Type Coffee Vending Machine	Model 9100	N° T.I. 10 - 2018
Serial Number 82310434	Subject CHANGE OF the 10" TOUCH SCREEN CARRIER BOARD	ISSUED FOR (X) Action Information X

U30 component

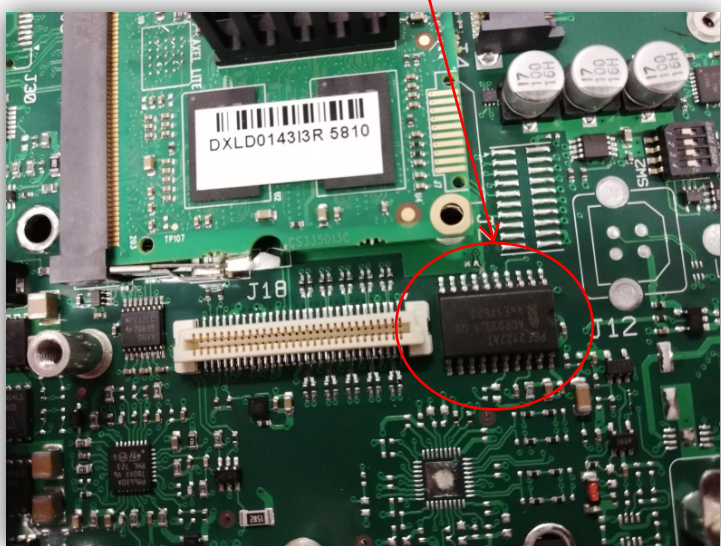
It is reported that in some case the internal battery of the carrier board, inserted in the 10" touchscreen, has been discharged prematurely.

A *pin* of the *U30* component, that it has been never used, is the root cause of the premature battery discharge.

So the *pin* has been disconnected by the touch screen supplier.

The **new** solution can be fitted on machines previous to above S/N.
